SIDDERS MODIFICATION FOR ACRO II AILERON BELLCRANKS

Neil Sidders
235 Rowland Road
Monroe, LA 71203

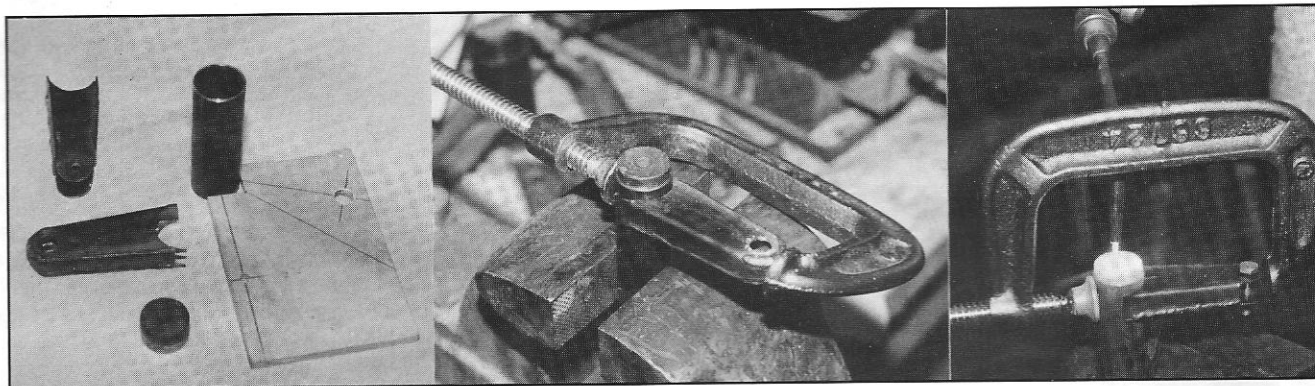
We modified the aileron bellcrank a little to simplify building. The bearing sleeve in ours is $2\frac{7}{8}$ " long, allowing both levers to be welded to the sleeve at 90 degree angles. (The Acro I wing is not thick enough to use this taller bellcrank). A plywood gauge was made to locate the angle of the levers to each other. A steel slug .900" in diameter is used to insert into the bearing sleeve when welding the levers to the sleeve. The slug keeps the atmosphere from the inside wall of the tube during welding and also keeps the ID of the tubing to the proper size for a KP-4 bearing.

^{SPACER}
Locate the bearing in the bearing sleeve as per the plans. Then tap the slug in until it contacts the spacer, clamp the lower arm to the bearing cage and prepare to weld. Start the weld by heating the slug to a bright red. This will allow you to weld the lever to the sleeve without losing your heat to the slug. After the part cools, you can knock the slug out and it will leave a good clean hole for the bearing.

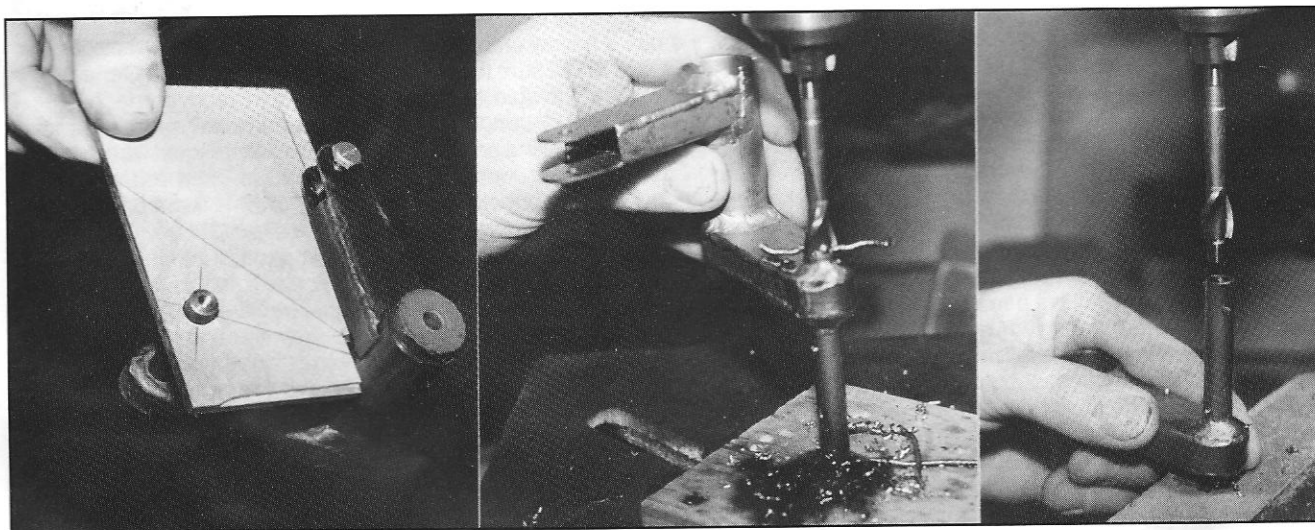
The steel slug is for insertion only during welding. Heat the slug before welding lever.

Plywood gauge to locate bellcrank levers. Squaring off ends of busing stock.

you?), and locate the upper lever as in the photo. Clamp the lever to the bearing cage with the slug in place and repeat the welding steps.
